**SPRIGGETTSBURY TOWNSHIP
PLANNING COMMISSION MEETING
Thursday, April 15th, 2021
6:00 PM (via Zoom)**

- a. Plans in Review:
 - i. LD.20.05/SD.20.02 – 4100 Lincoln Highway (project placed on hold by developer).
 - ii. SD.20.03 / LD.20.09 – 2841 East Prospect Road.
 - 1. We are concerned about the alignment of Cortleigh Drive and deem this as a high potential conflict.
 - a. We have modified the driving path of the vehicle to show what we believe would be driver behavior. As you can see from the exhibit provided these two vehicles overlap.

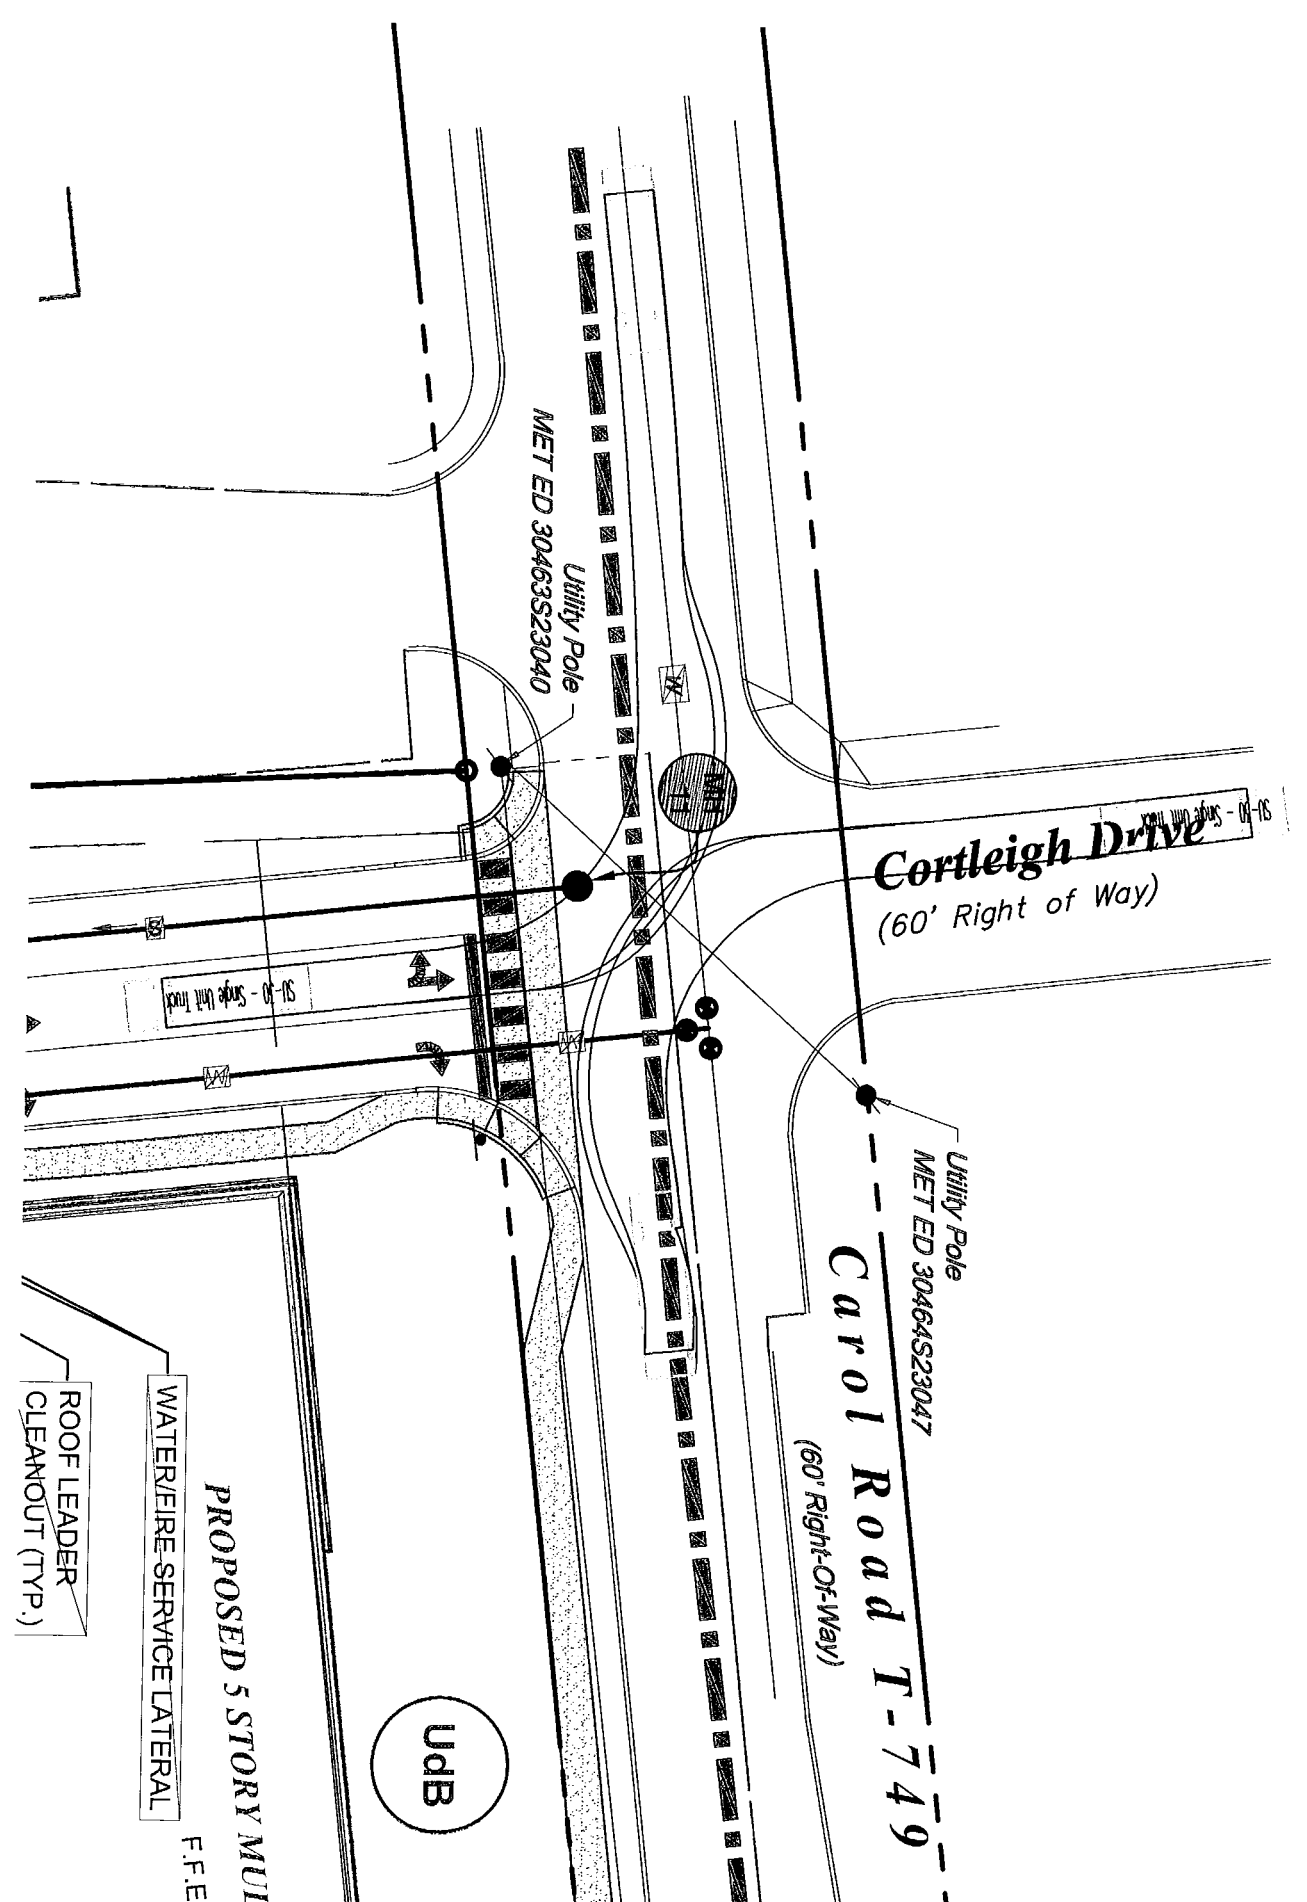
This does not include turning movements from the adjoining parcel owned by Strictly Fitness. Typically, good traffic design aligns the centerline of the left turning vehicles simultaneously.

- i. As a driver on the proposed access drive makes a left onto Carol Road, he will stop and then begin his turn.
 - ii. While a driver traveling south on Cortleigh Drive will stop as he travels uphill to determine when it is safe to enter the roadway, then begin his turn.

- b. Our ordinance requires spacing of driveways, and a minimum of 20-foot distance from the property line. We suggest that they shift their entire driveway 12 feet to the left OR revise their entire network and shift the proposed driveway to the east.

2. The Stormwater Plan and Erosion & Sedimentation Control Plan show that the drainage area ends at the curb line on the south side of Carol Road. Currently, the homes on the north side of Carol Road drain to Carol Road. Carol Road is sloped in a single direction toward this site. Therefore, accommodations to accept this run-off must be provided.

- a. In the last submission, the consultant had not provided any survey information along Carol Road. Apparently that work has been completed and cross sections have been drawn.

- b. The township design standards require a 2% cross slope which is not provided and a minimum of a 1% longitudinal slope. There are places along Carol Road where the slope is 0%.

- c. This design should reprofile Carol Road to allow water to safely drain away from the gutter.
